UNITED STATES PATENT AND TRADEMARK OFFICE

10/799,143

Office Action Summary	Application No. 10/799,143	Applicant(s) BIEDERMANN ET AL.	
	Examiner MARY HOFFMAN	Art Unit 3733

DETAILED ACTION

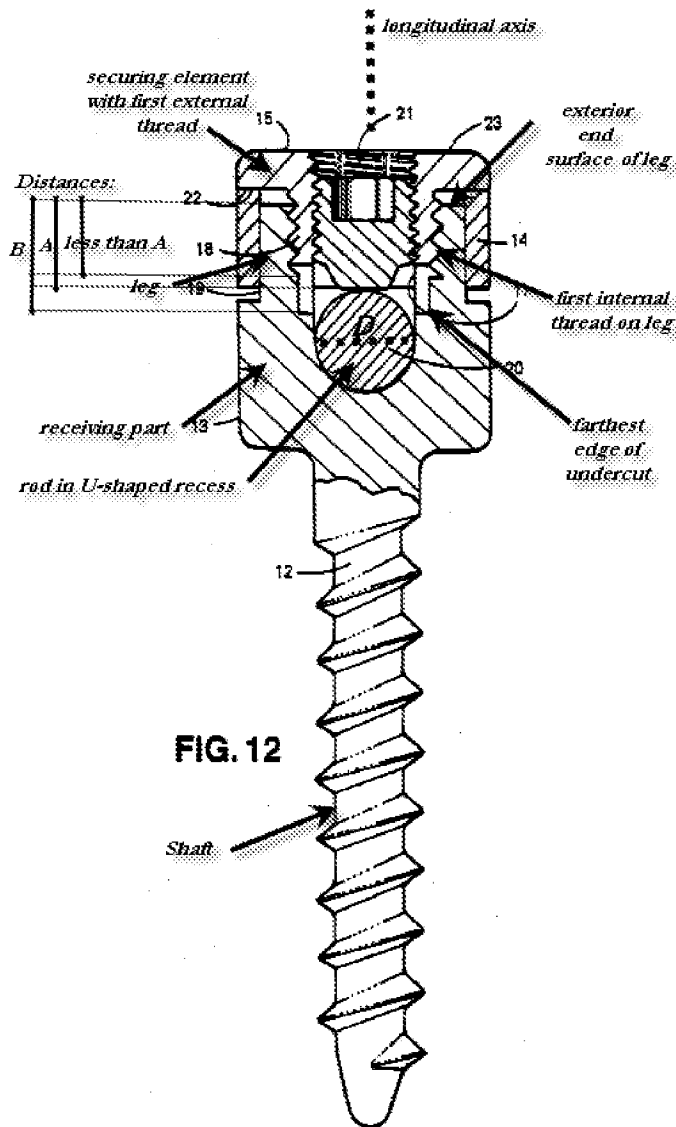
Mehdiian discloses an anchoring element (See marked up figure below) for use in spinal or bone surgery; the anchoring element comprising: a shaft for anchoring in a vertebra or a bone section; a rod having a pre-determined diameter (D) and an outer surface; a receiving part, which is connected to the shaft and is structured and arranged to connect to the rod, the receiving part having a longitudinal axis and comprising a U-shaped recess forming a channel for the reception of the rod and two legs having free ends, the legs comprising a first internal thread, the legs further providing an exterior end surface of the receiving part; and a securing element comprising a screw member having a first external thread that engages and cooperates with the first internal thread; whereby a first distance from the exterior end surface of the receiving part to a closest portion of the outer surface of the rod in an axial direction is a pre-determined distance (A); the first internal thread extending from the exterior end surface of the receiving part to a second distance that is smaller than or equal to the pre-determined distance (A);

and the receiving part further comprising an undercut (*i.e.* a cut made in a lower part: a cut made below another cut or into the lower part of something- see Encarta® World English Dictionary, North American Edition online for definition) extending circumferentially and the first internal thread extending to the undercut, the undercut having an edge farthest away from the first internal thread, the edge being located at a third distance (B) from the exterior end surface, the distance (B) being larger than the predetermined distance (A). A connection between the shaft and the receiving part is structured and arranged to be a monoaxial connection. The shaft and the receiving part are an integral part. The first thread comprises fewer than four full turns.

Applicant argues that Mehdian lacks an undercut. The term "undercut" does not necessarily require an overhanging part. According to Encarta® World English Dictionary, North American Edition online, an undercut is a cut made in a lower part: a cut made below another cut or into the lower part of something. The hollowed out portion beneath the threaded region of the Mehdian reference meets this definition. The hollowed out part extends circumferentially.
